LAND USE APPLICATION SUMMARY

Property Location: 2200-2218 Snelling Ave
Project Name: The Bessemer at Seward
Prepared By: Janelle Widmeier, Senior City Planner, (612) 673-3156
Applicant: Seward Redesign Inc.
Project Contact: Renee Spillum
Request: To allow a new multiple-family dwelling with 121 units.
Required Applications:

Variance	To increase the maximum allowed size of a projecting sign from 20 square feet to 48 square feet to allow a projecting sign facing Snelling Avenue.
Site Plan Review	For a new 5-story residential building.

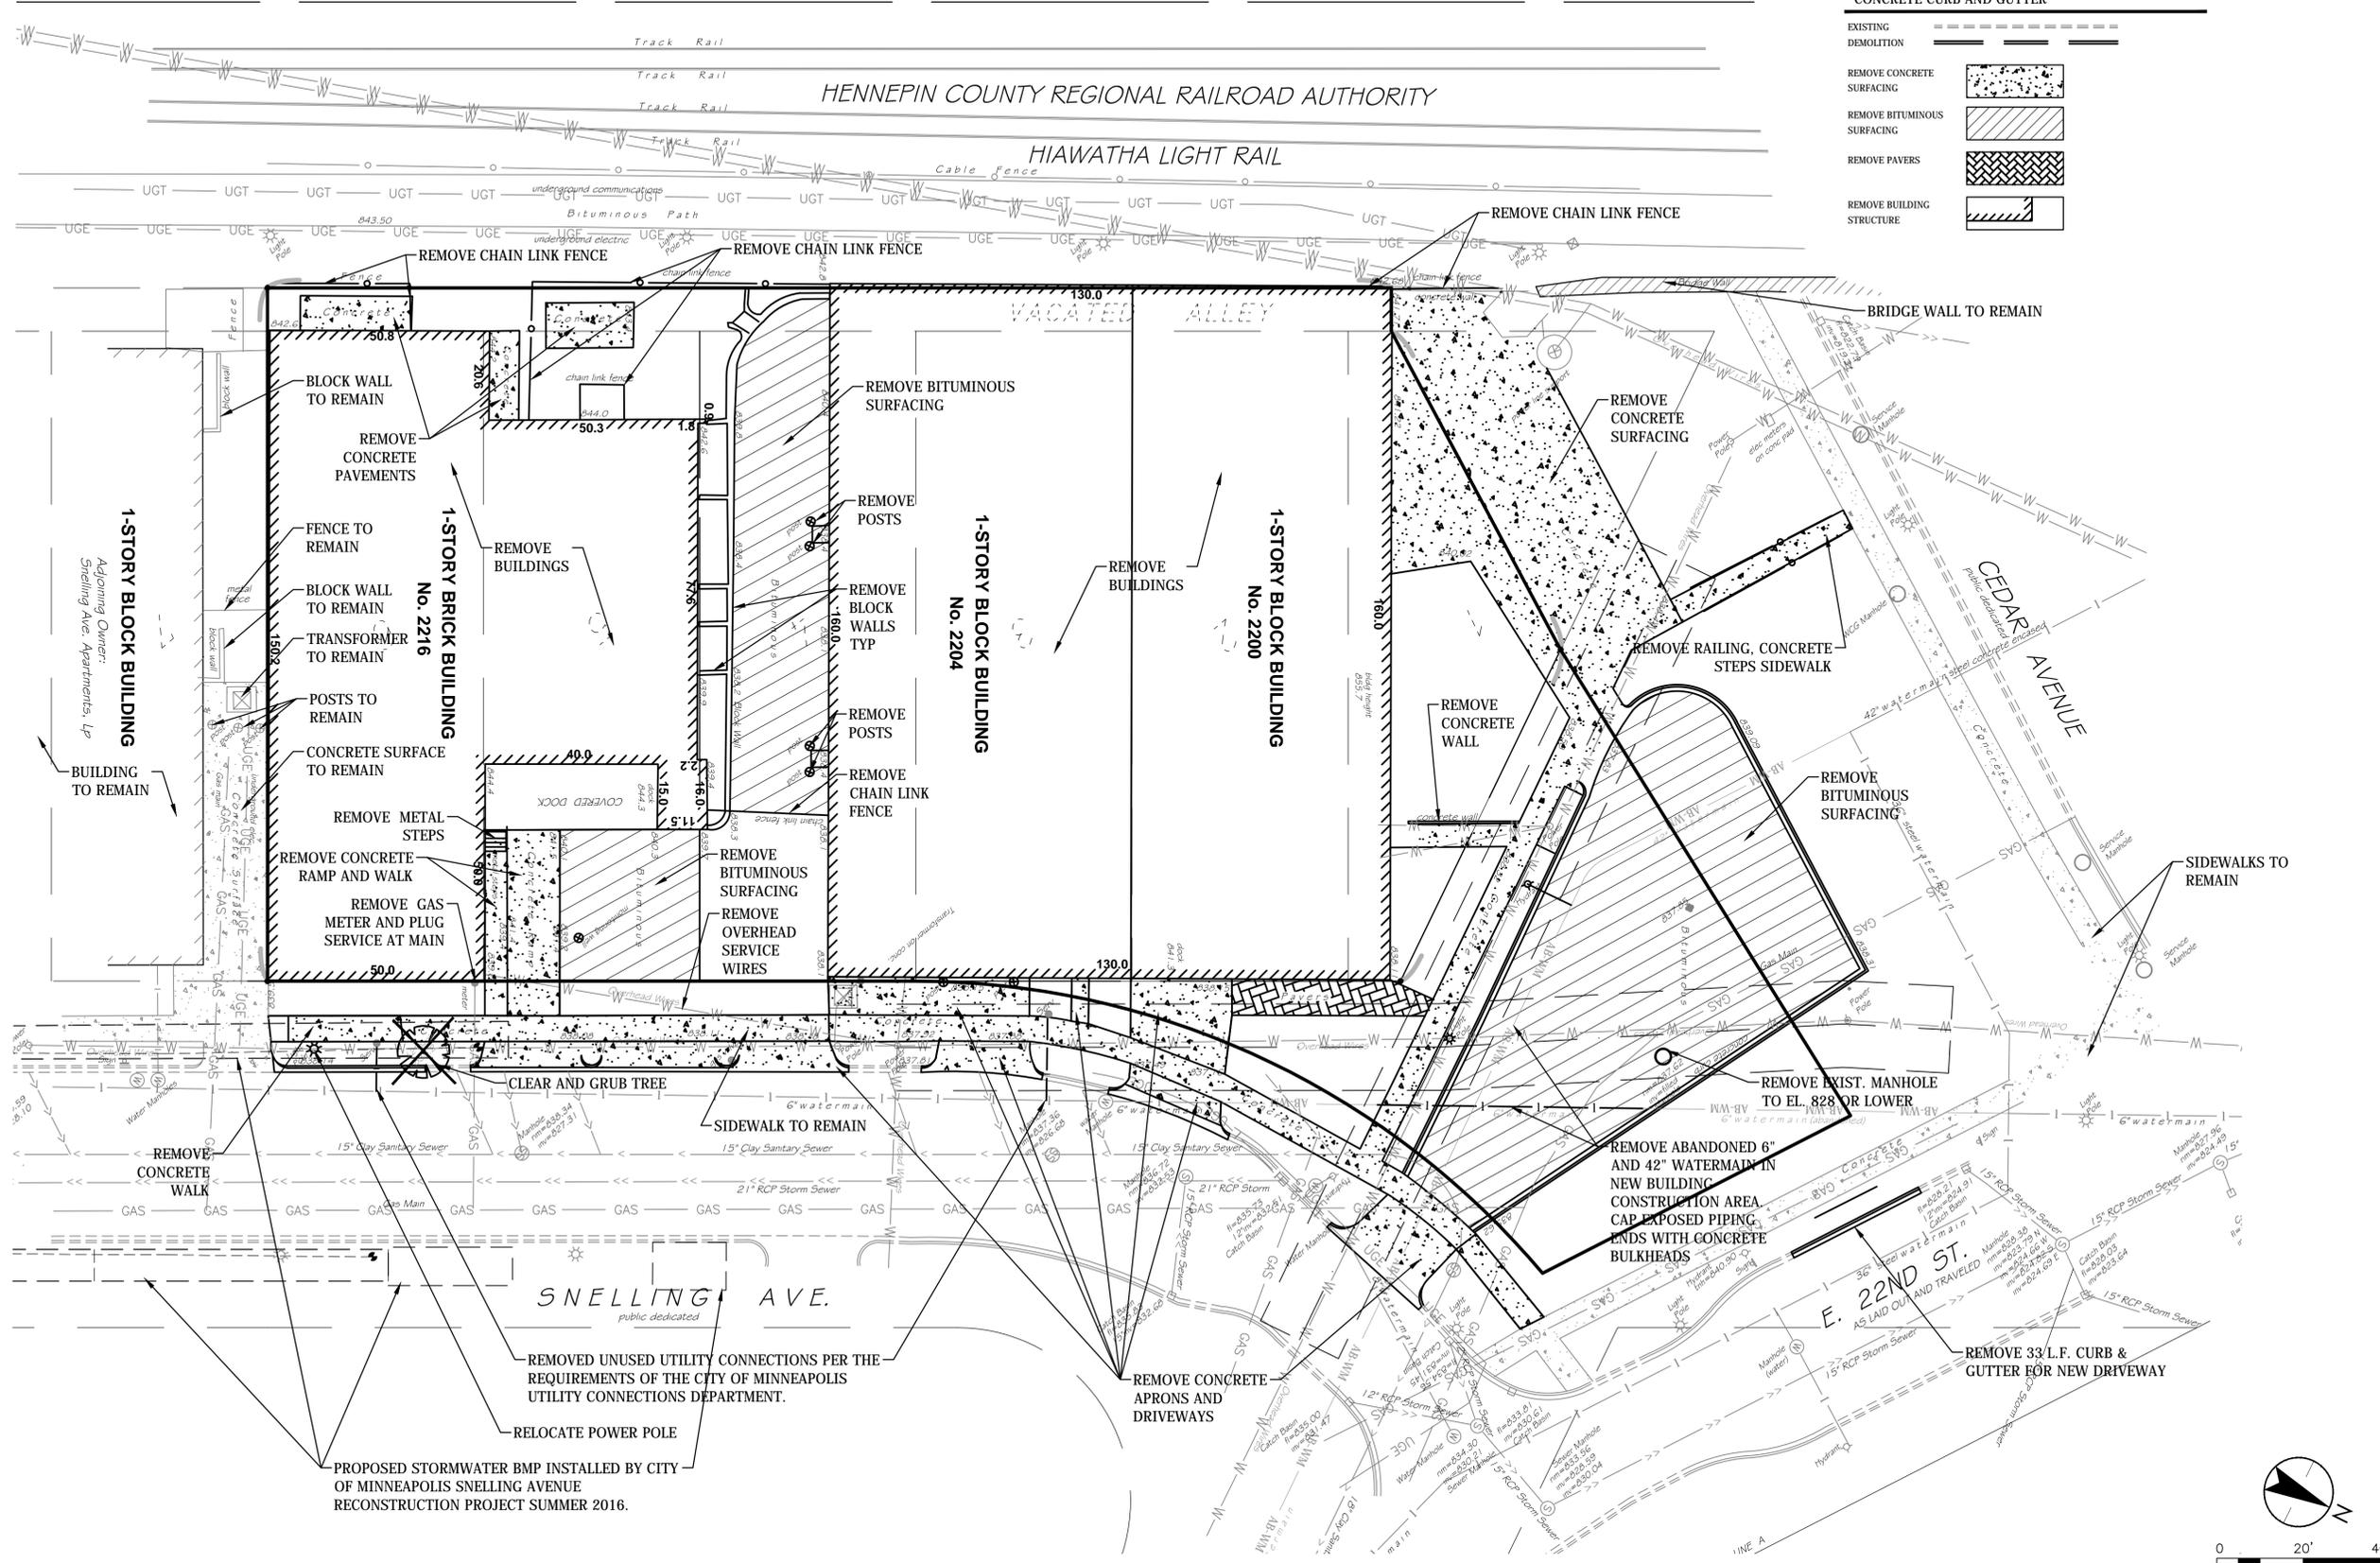
- The linetypes and symbols used in the plans do not match those on the legend on Sheet G0.01. This appears to be the case for some utilities, survey lines and grading information.
- There is an existing sanitary sewer manhole within the boulevard of Snelling Avenue, near the 22nd St E intersection, that does not appear to be shown on the plans.
